Changes to original TI schematic shown at right

APPROVALS		DATE	TITLE		
DRAWN	J TAYLOR	05/20/09	TI AP-NOTE NIXIE CLOCK		
CHECKED					
ENGINEER					
PROJ ENGINEER			SIZE	FSCM NO.	DRAWING NO.
APPROVED			B		1384.DSN
QA			SCALE	NONE	REV. -
			© 2009 TES	MODIFIED: 06/21/09 2:54:56 PM	SHEET 4 OF 4

Fig. 12.4. 12-hour digital clock.

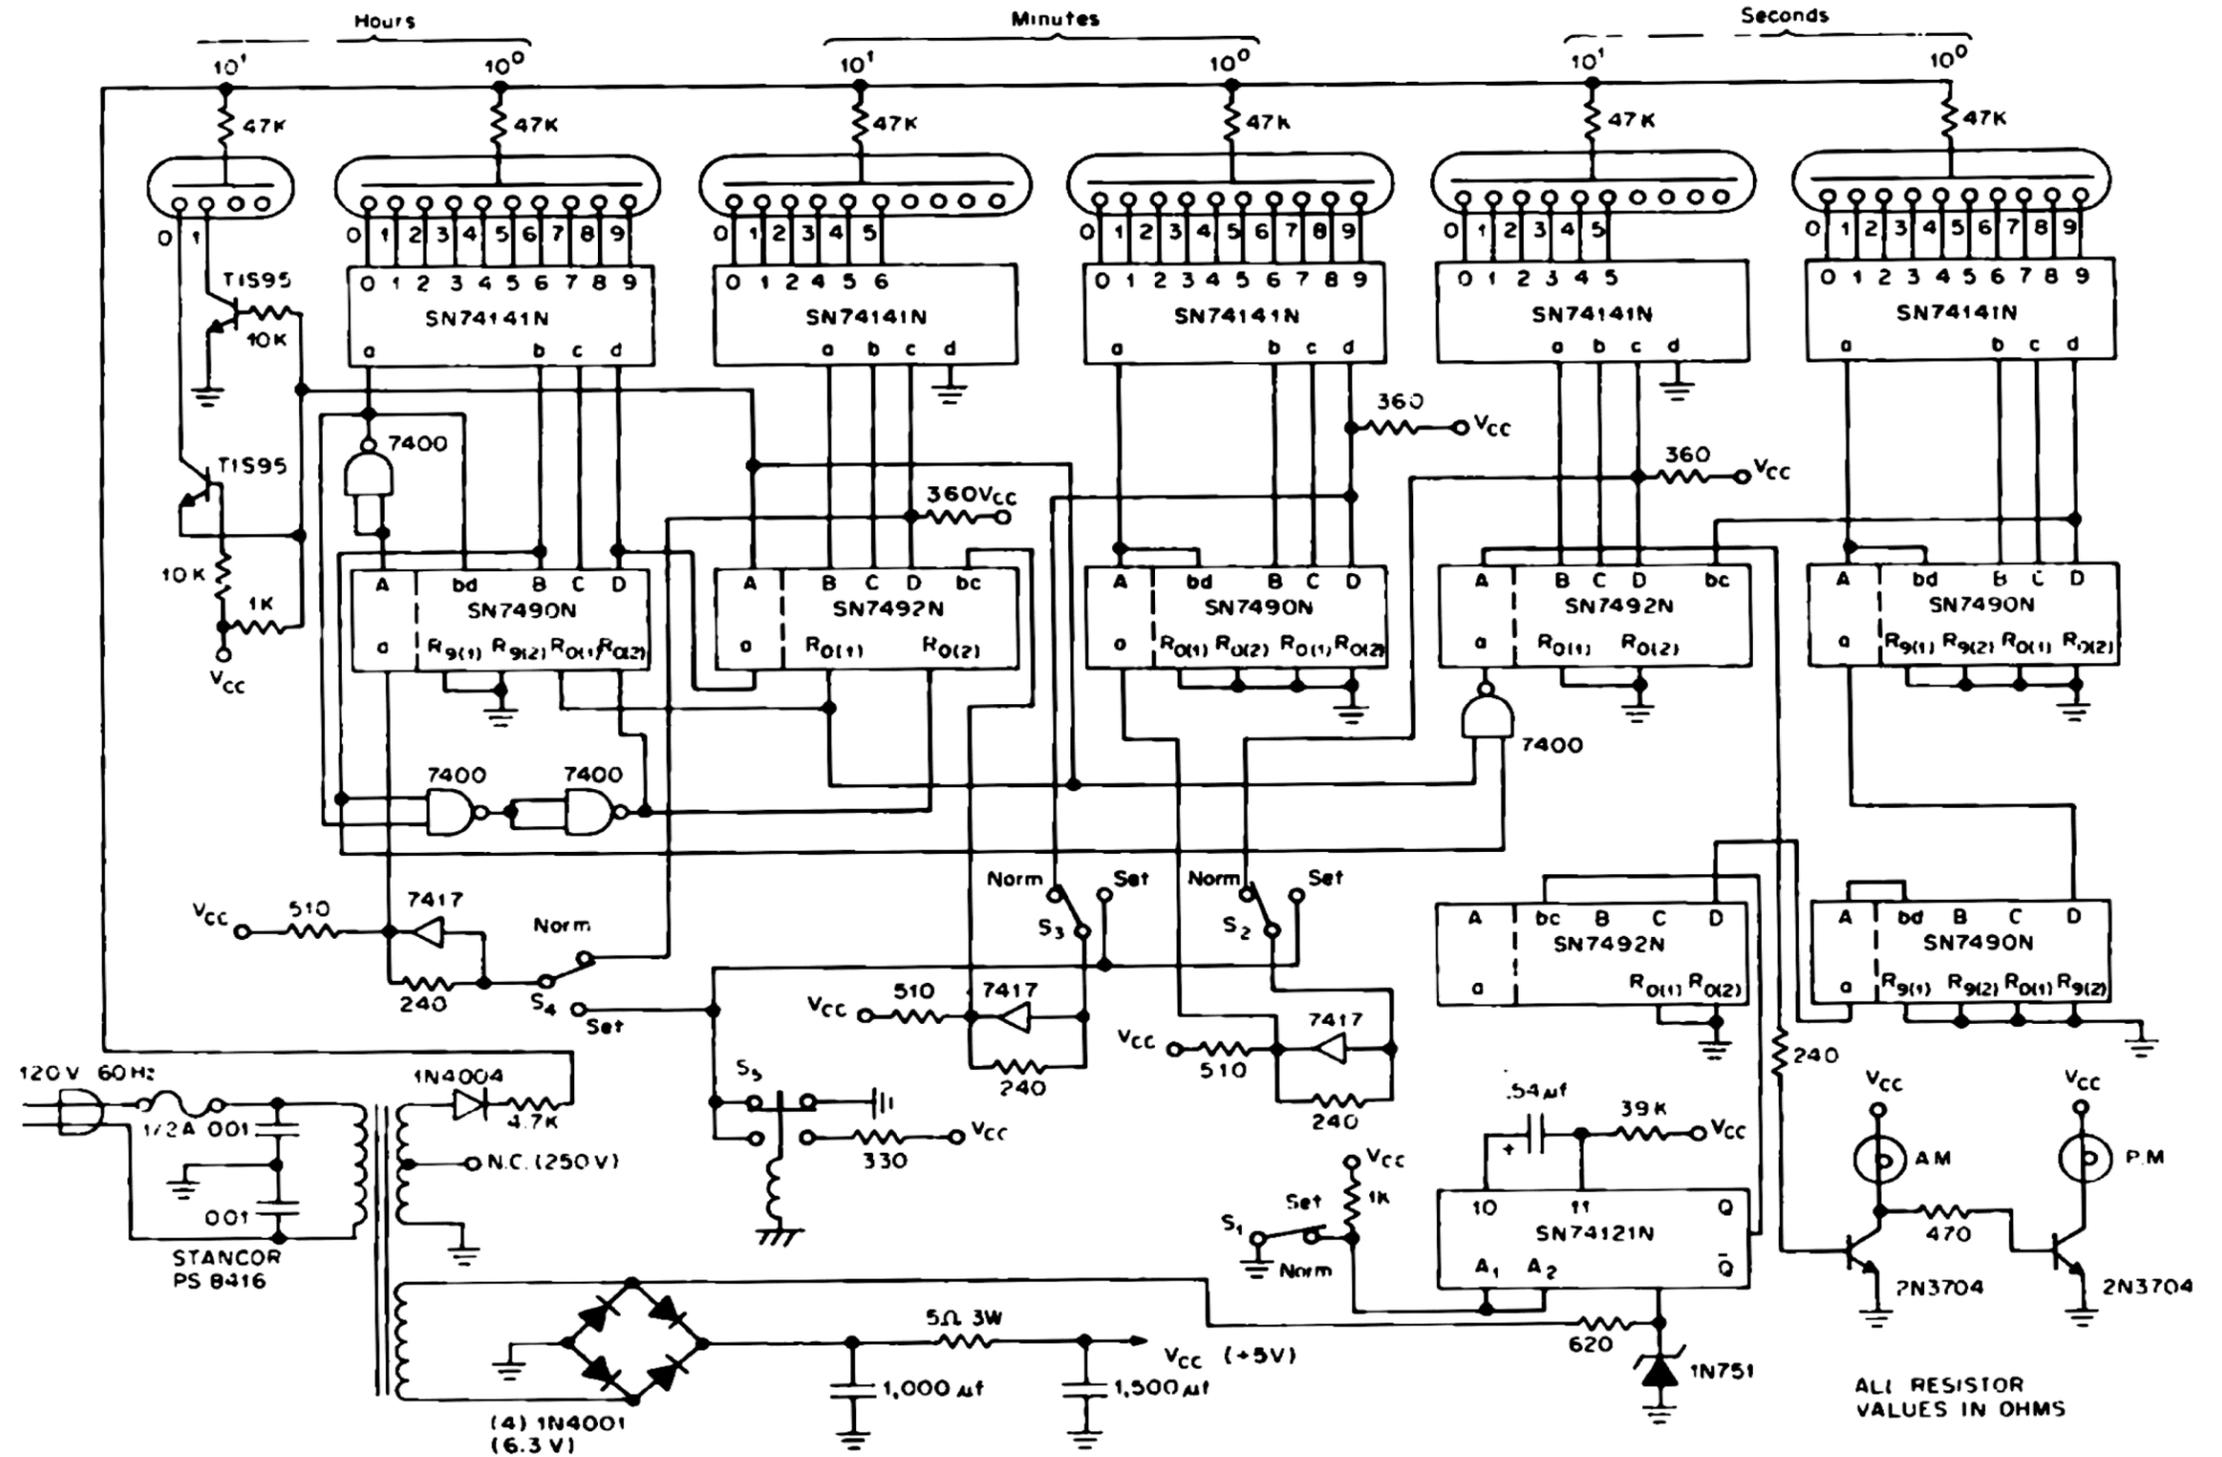
1. Seconds 10's decoder to nixie connections changed to match minutes 10's: Upper 3 bits of 7492 count 0,1,2,4,5,6 and not 0,1,2,3,4,5.
2. Changed AM/PM driver to NE2 from incandescent for aesthetics.
3. Connected HALT switch to seconds and prescaler reset to zero them to allow easier exact second alignment on release (S1).
4. Changed high voltage from transformer output to boost module.
5. Changed 5V supply from zener shunt to LM7805 to improve performance and eliminate power resistor.
6. Selected Q output on one 74121 one-shot.
7. Minutes 1's 7490 counter shows R0(1)/R0(2) twice, second set should be R9(1)/R9(2).
8. Increment resistor changed to 360 ohms from 330 (S5).
9. Anode resistors changed to 20K for IN12's running at 170V.
